Date: 29 September 2022
To: All Plan Holders
Subject: ADDENDUM NO. 2
Project: TROY UNIVERSITY HWY 231 ENTRY SIGN
Job #: SSL# 22016
TROY BID# 22-038
From: Cody Smith

The Plans and Specifications dated September 2022 of the subject project, and any subsequent addenda are amended as follows: (Where there are conflicts between the plans and specifications and the addendum, this addendum shall govern)

5 A5.2 WAYFINDING ELEVATION 1/2" = 1'-0"

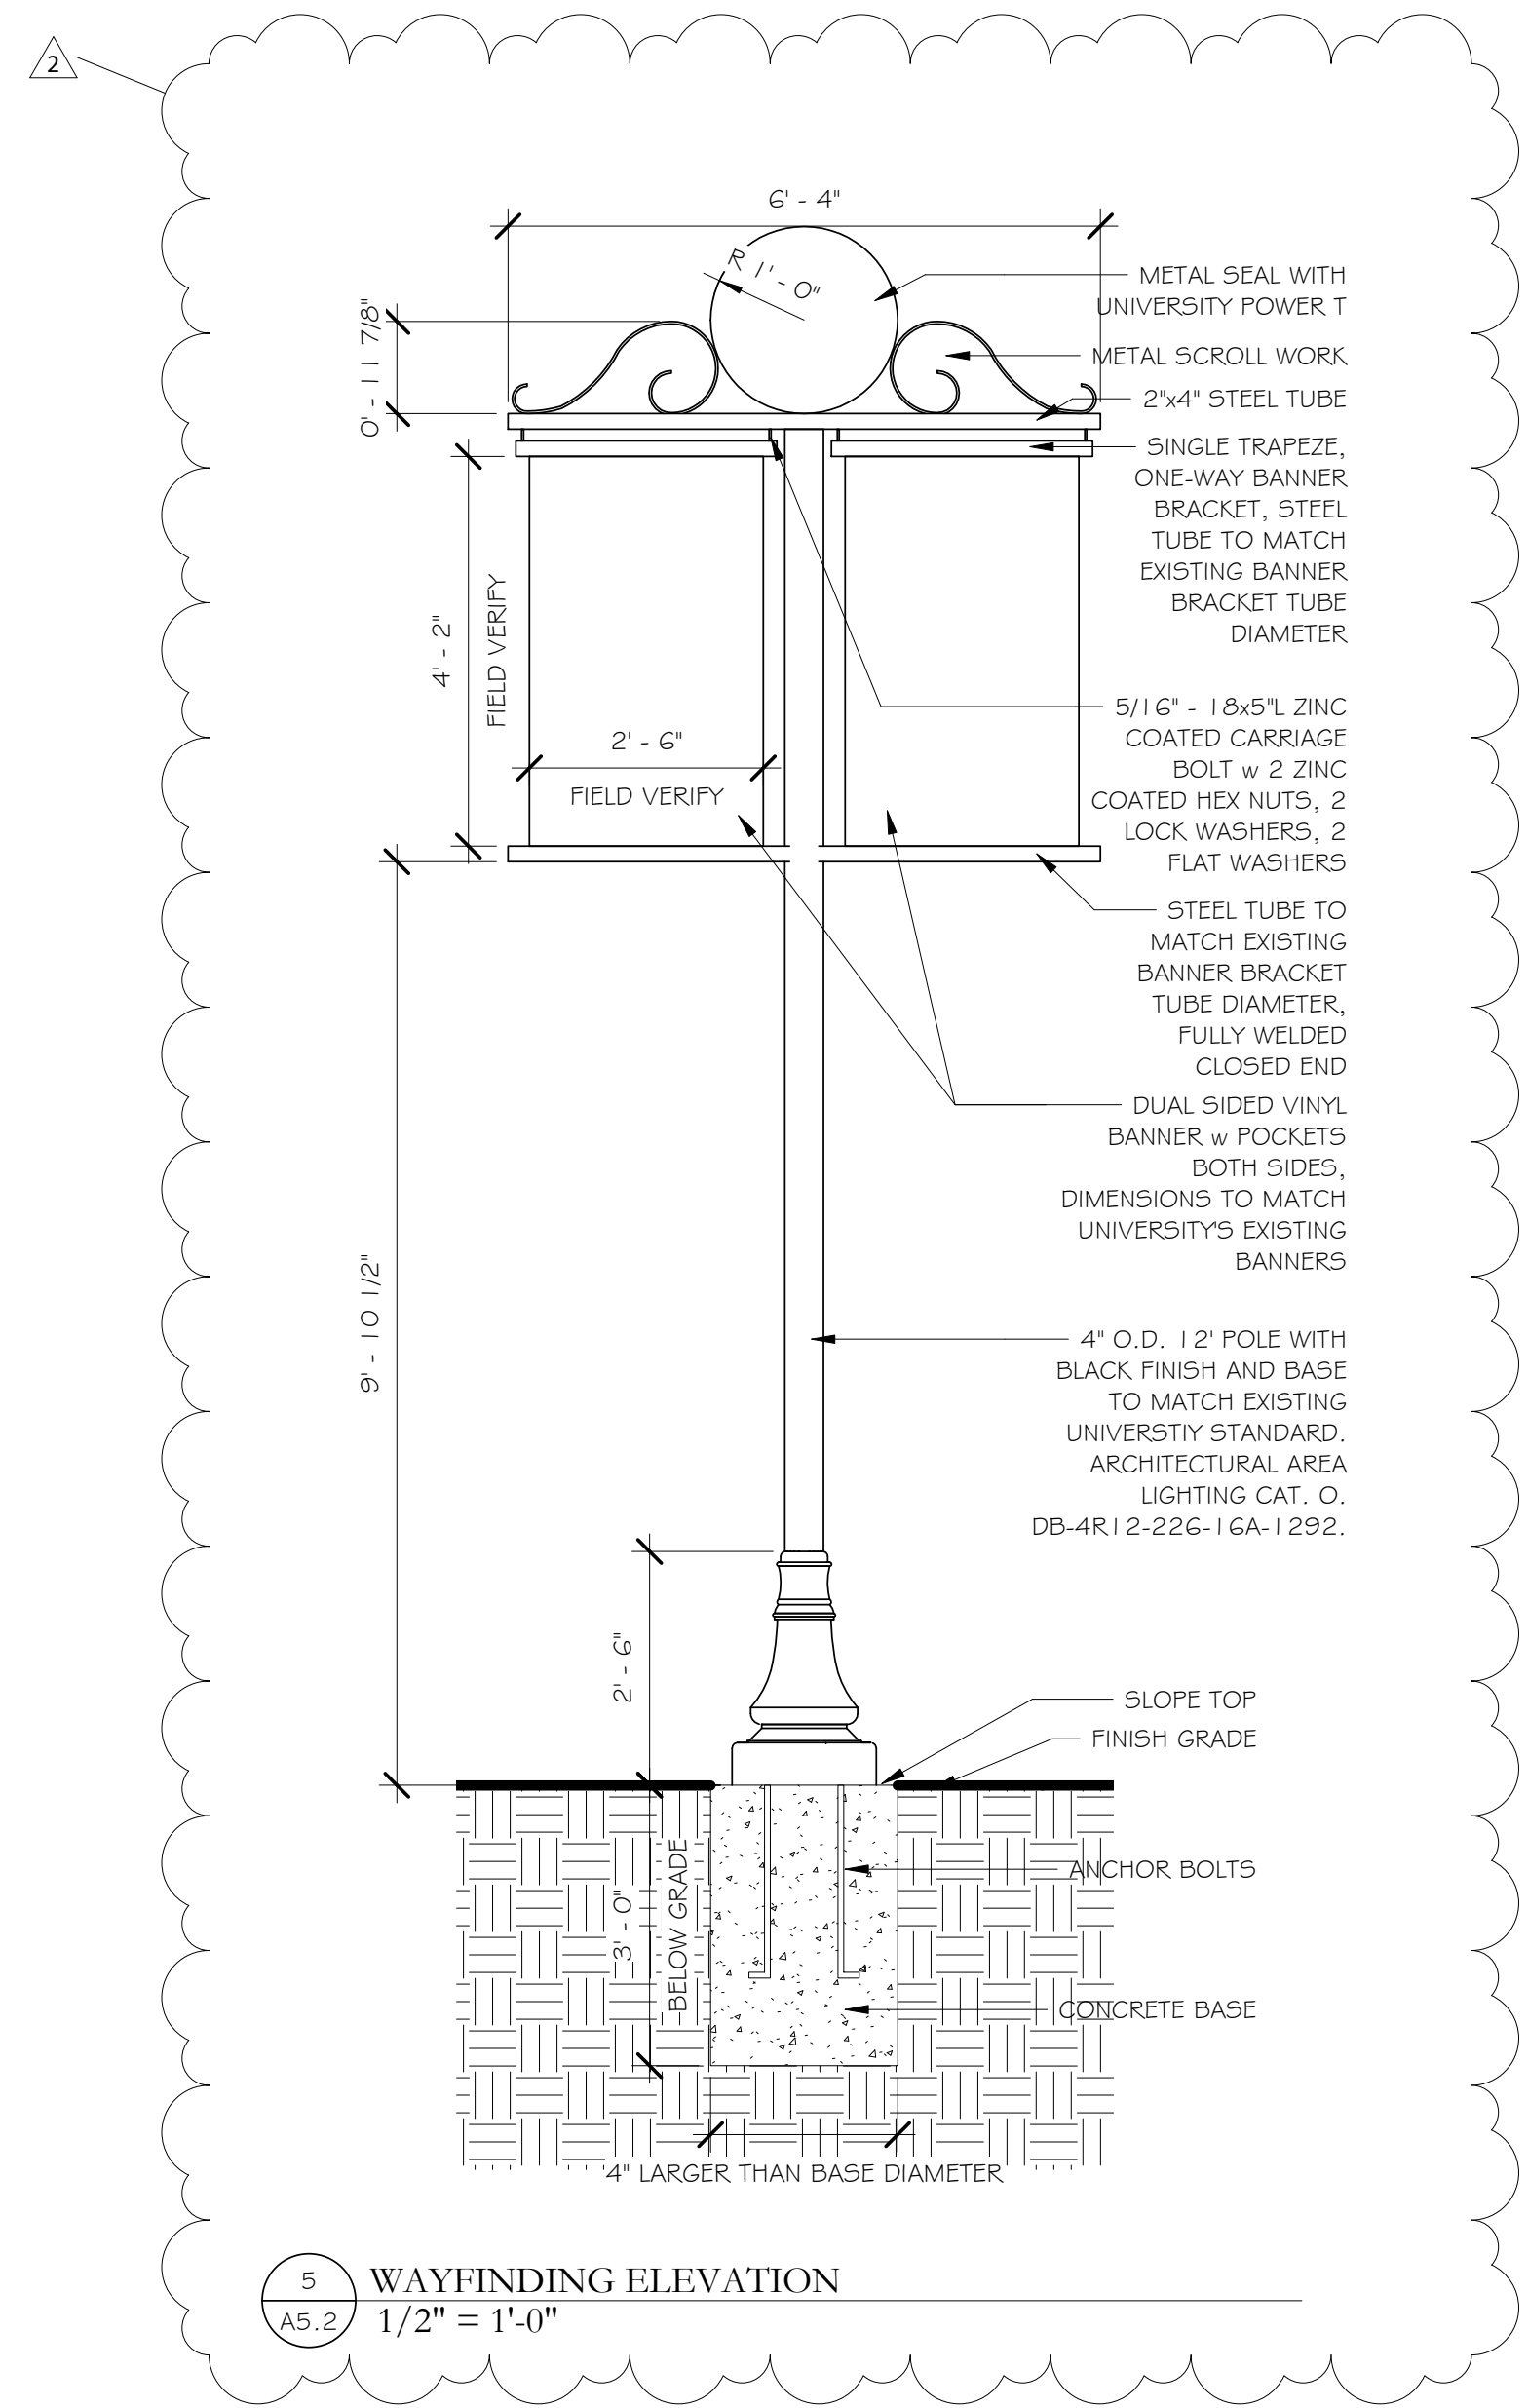
Item 4: Refer to Drawing A5.2 and replace with attached. Clarified Wayfinding Sign Banner.

8 GATE COLUMN
3/4" = 1'-0"

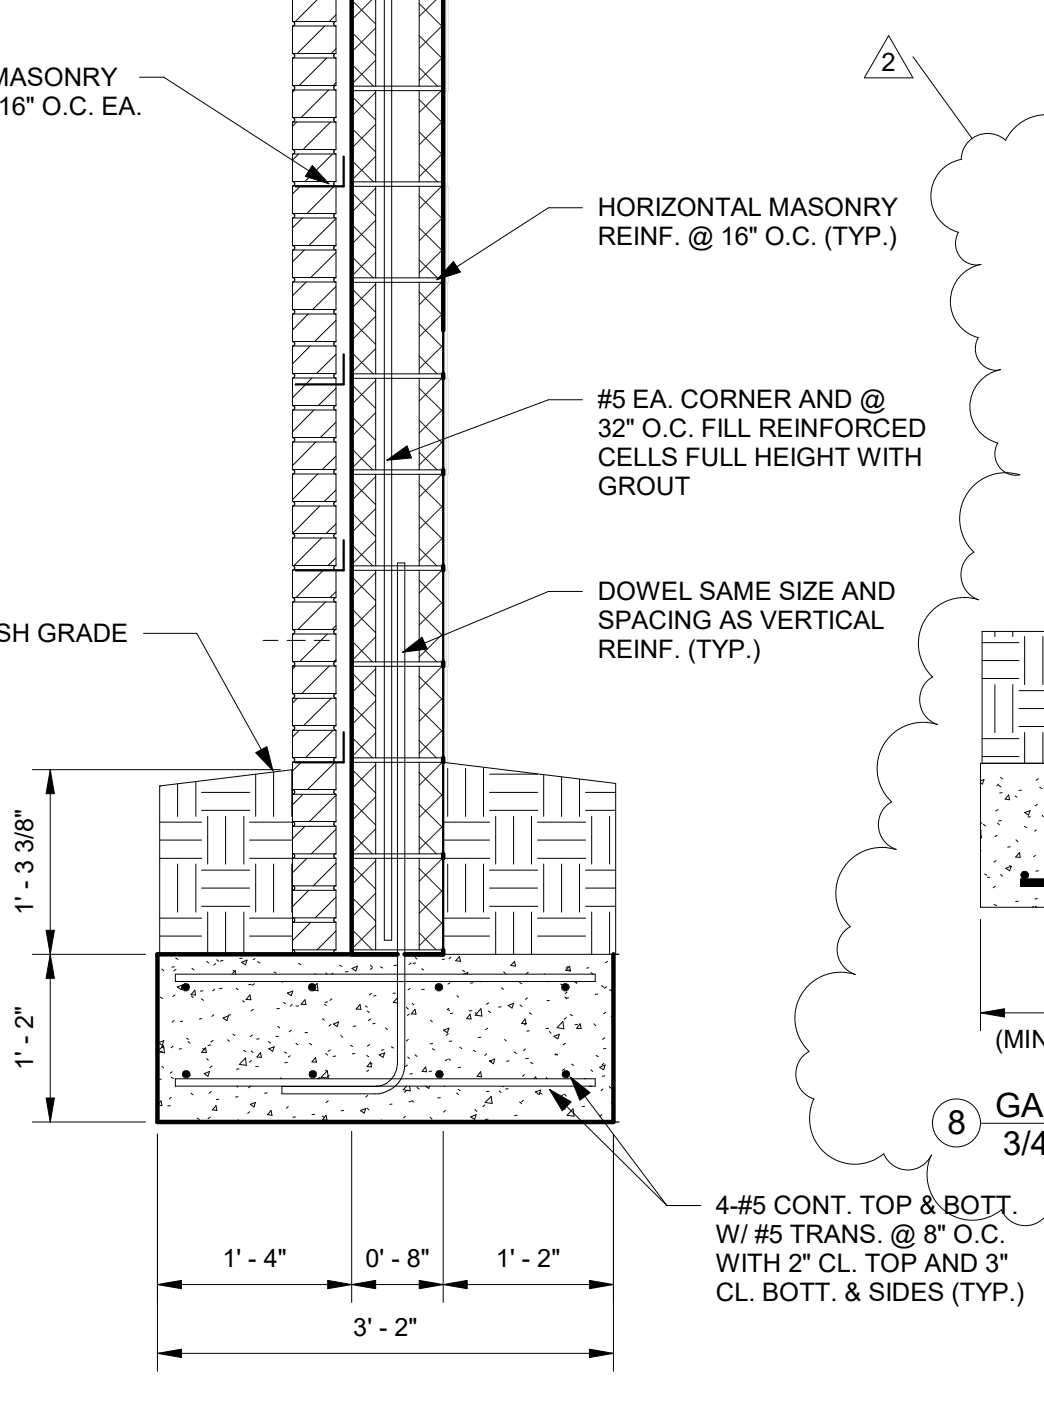
Item 6: Refer to Structural Drawing S3.1 and replace with attached. Added Gate Column Detail 8.

E1.0

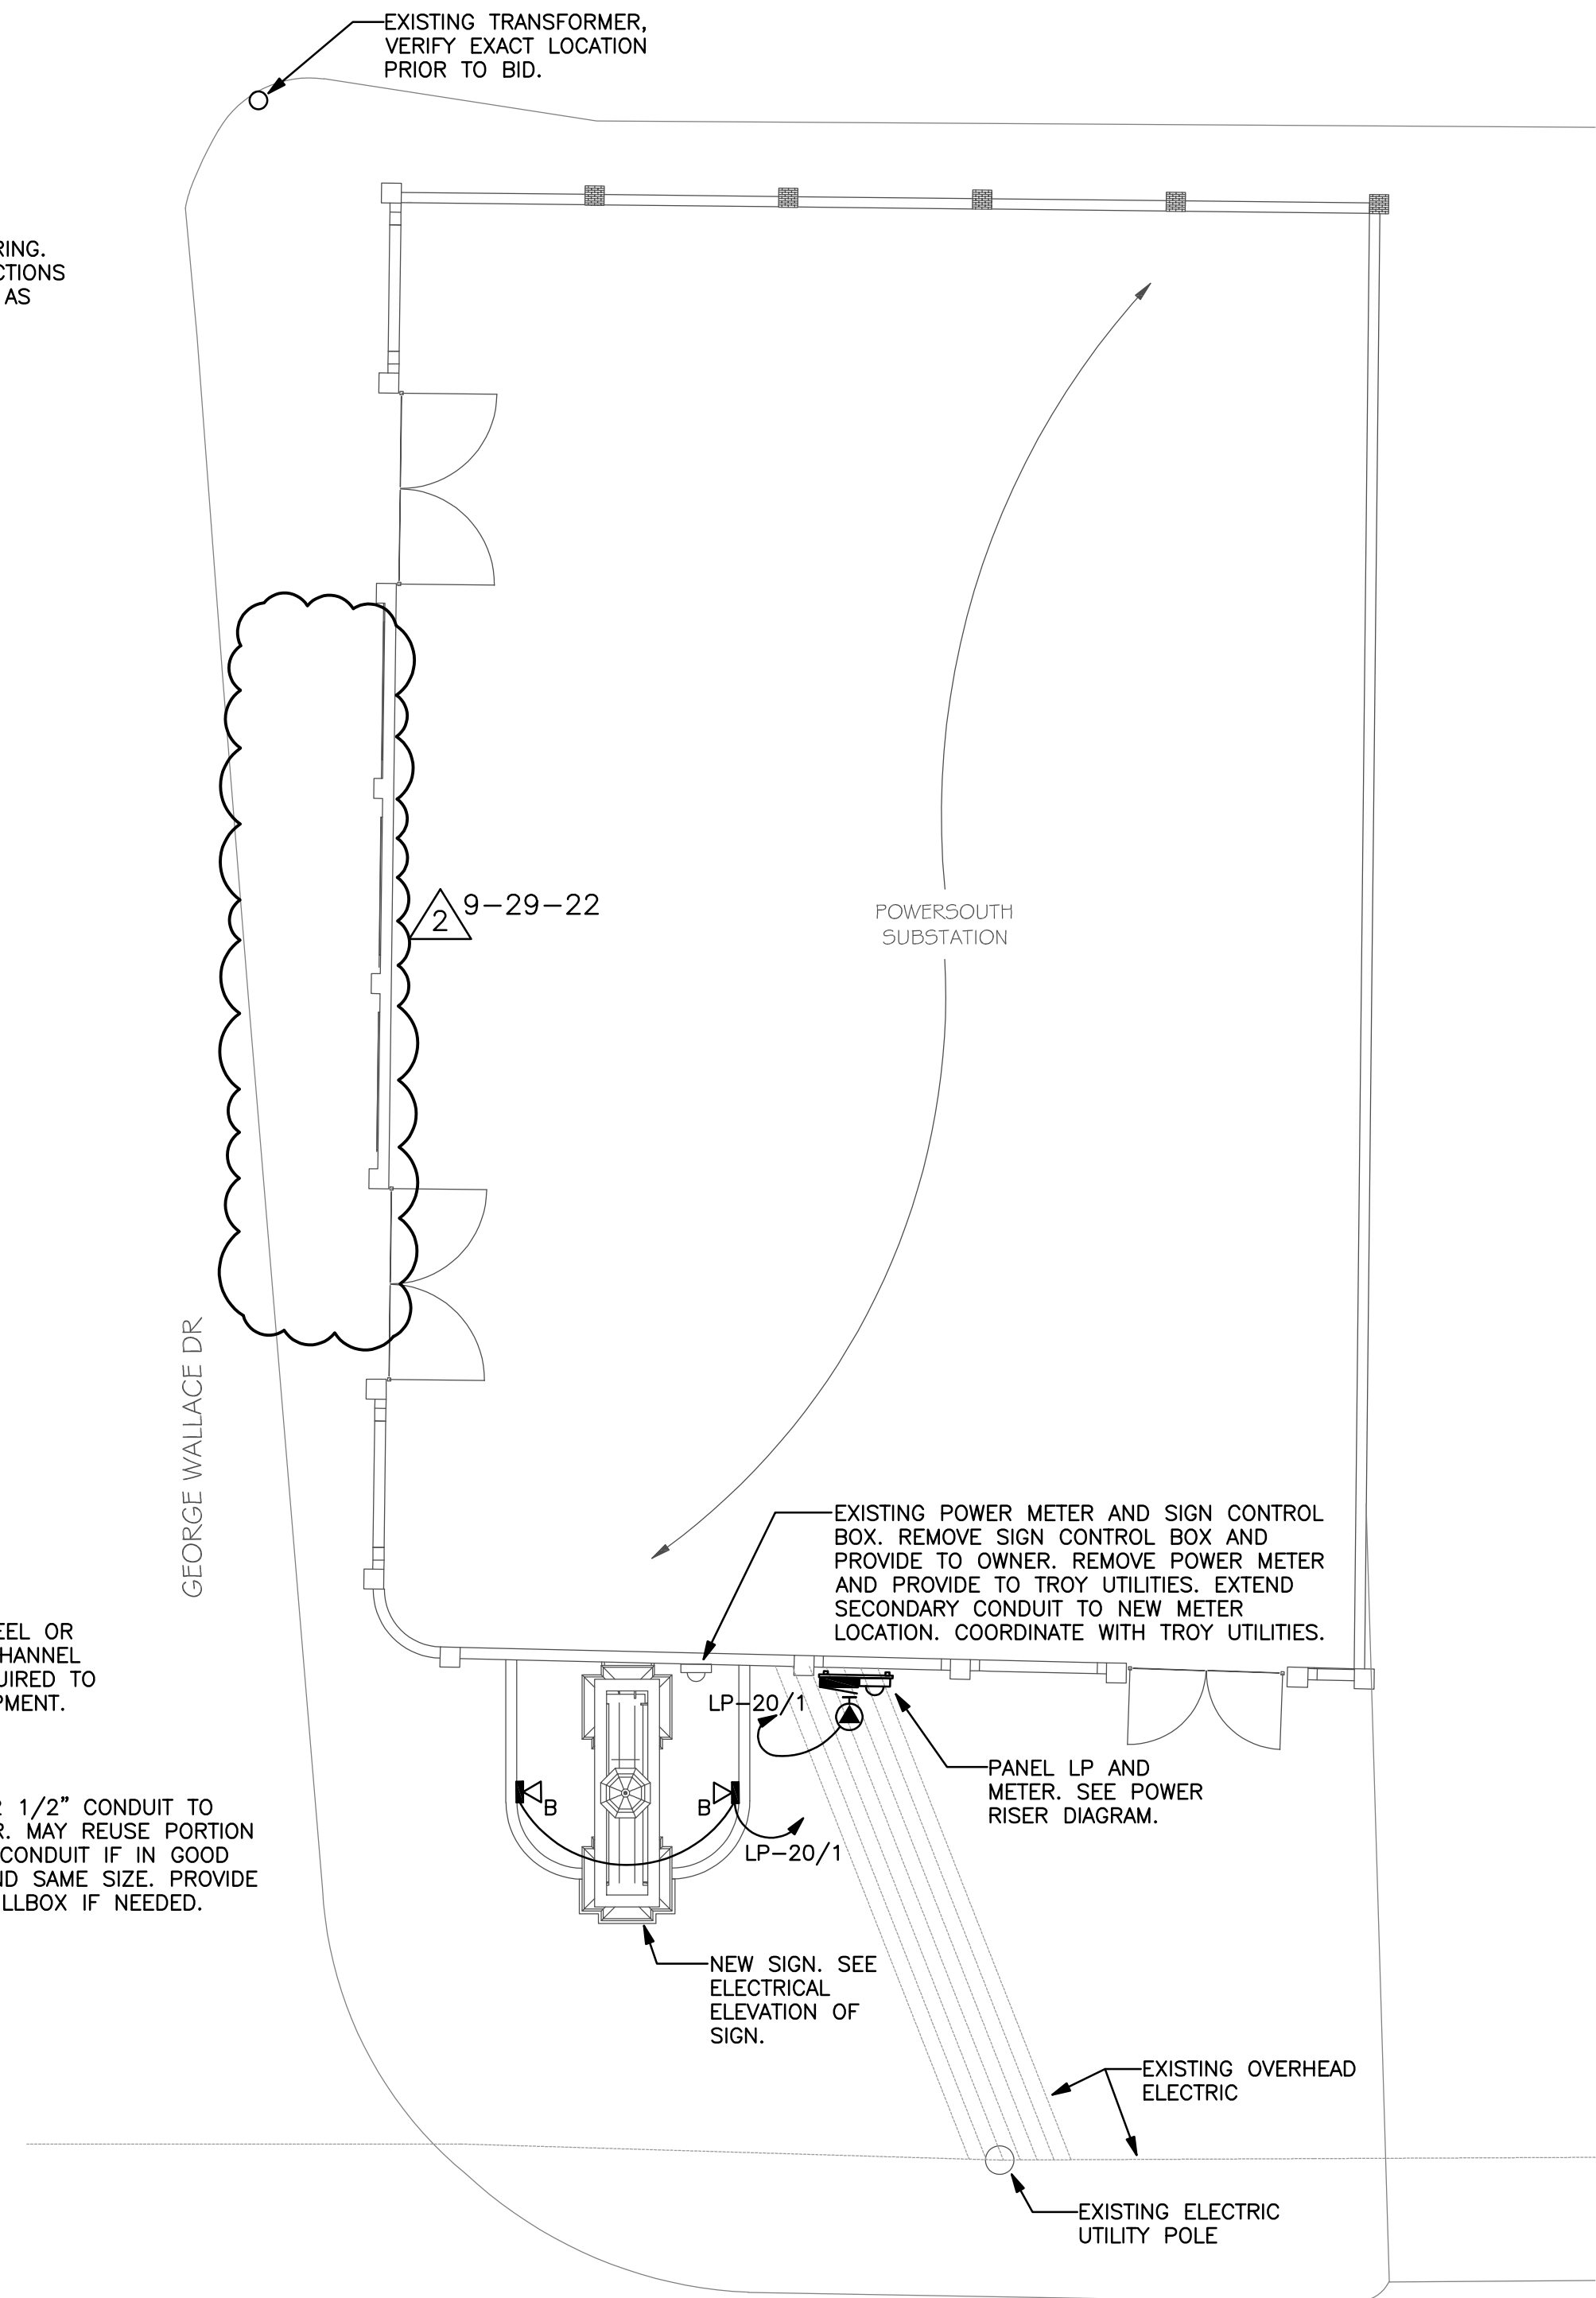
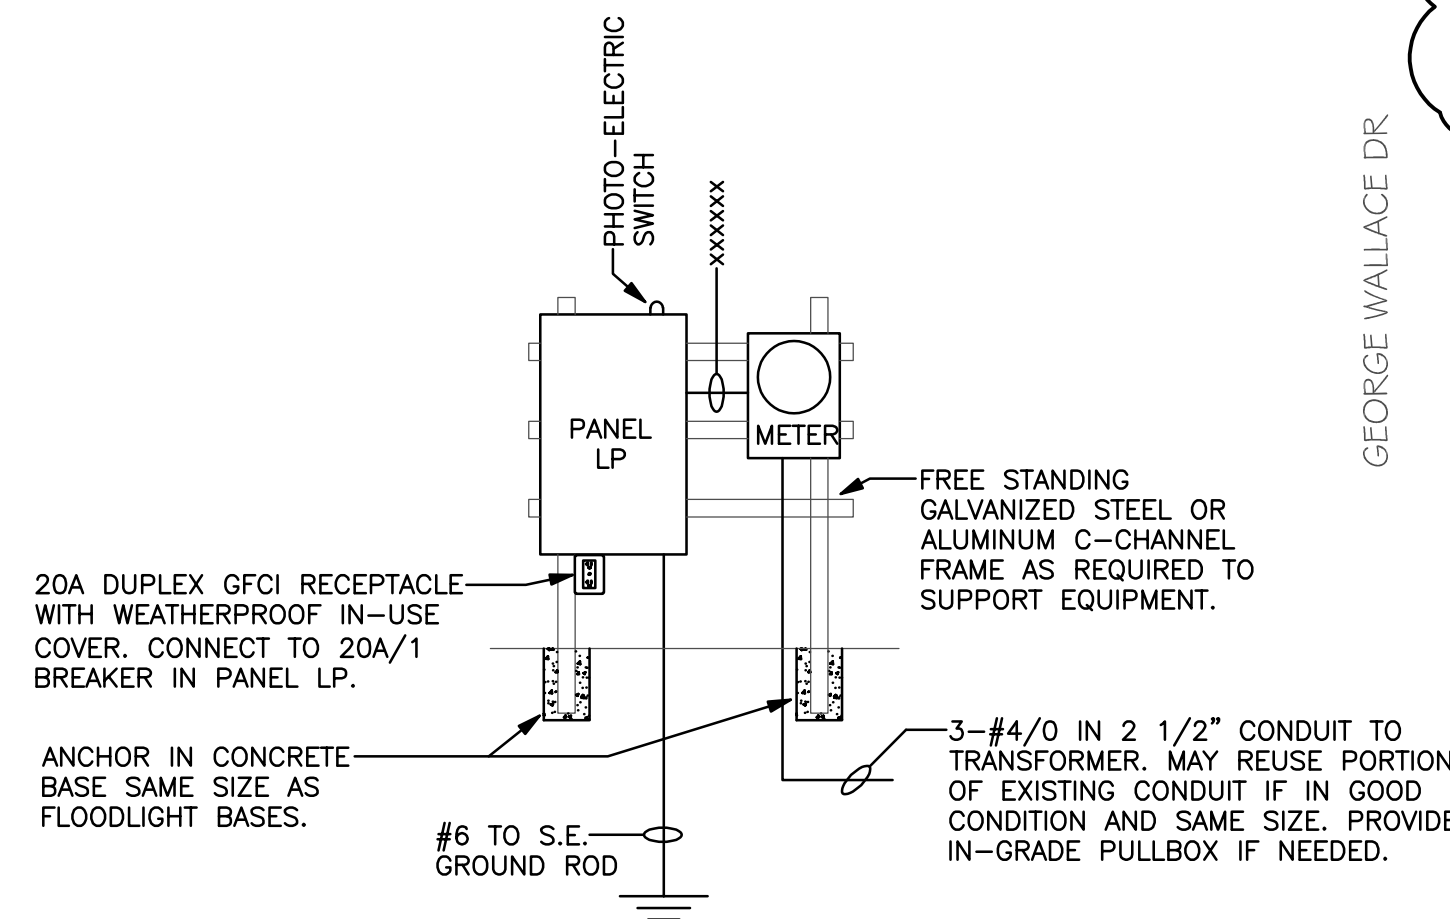
Item 7: Refer to Electrical Drawing E1.0 and replace with attached. Removed Screenwall floodlights.
